Access Compliance Report

Public Rights-of-Way

Intersection ID: 53270	Main Street: MONROE_RD	Cross Street: MERIDIAN_CENTER_DR	Location: NE
ADA ID: 84AA31CECF00	Ramp Type: Directional1	Initial Pass/Fail: Pass	Overall Compliance: No
		Severity Score: 10

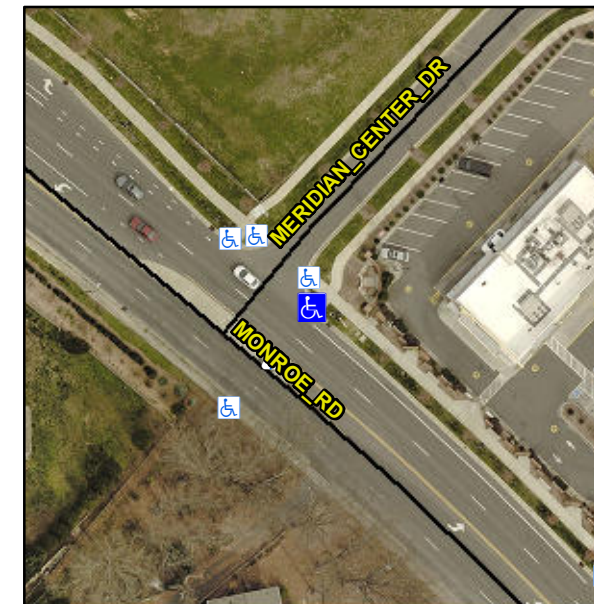
R304.5.2, R305

Compliance	Description	Data	Compliance	Description	Data
N/A	Ramp Length (in)	71.0	No	Grade Break?	No
Yes	Ramp Width (in)	69.0	N/A	Grade Break Slope (%)	1.4
Yes	Ramp Slope (%)	5.2	N/A	Grade Break XSlope (%)	1.6
Yes	Ramp XSlope (%)	0.4			
Yes	Flare Type LT	N/A	Yes	Flare Type RT	N/A
N/A	Flare Slope LT (%)	N/A	N/A	Flare Slope RT (%)	N/A
N/A	Flare Traversable LT?	No	N/A	Flare Traversable RT?	No
Yes	Landing Length (in)	70.0	No	DWS Provided?	No
Yes	Landing Width (in)	69.0	N/A	DWS Contrast?	No
Yes	Landing Slope (%)	1.2	N/A	DWS Length (in)	N/A
Yes	Landing X Slope (%)	0.9	N/A	DWS Full Width?	No
N/A	Landing Curb? (Y/N)	N/A	N/A	DWS Offset LT (in)	N/A
N/A	Shared Landing?	Yes	N/A	DWS Offset RT (in)	N/A
Yes	Gutter Ponding?	No	Yes	Gutter Slope (%)	3.7
Yes	Gutter Lip Ht (in)	0.0	Yes	Gutter X Slope (%)	1.0
N/A	Painted X Walk1?	No		Road Slope (%)	2.1
	X Walk 1 Direction	To SW		Road X Slope (%)	1.4
	X Walk 1 Width (in)	N/A		Clear Space?	Yes

X Walk 1 Slope (%)	2.1	N/A	Clear Space to XWalk (in)	N/A
	X Walk 1 X Slope (%)	1.4	Yes	Storm Grate/Utility Hazard?	No
N/A	Ramp inside XWalk1?	N/A		Storm Grate/Utility Type	
Yes	Any Obstructions?	No			N/A
	Obstruction Type		Yes	Surface Condition? (G/P)	Good
			N/A	Curb Slope (%)	6.0

Remove & Replace Entire Ramp.
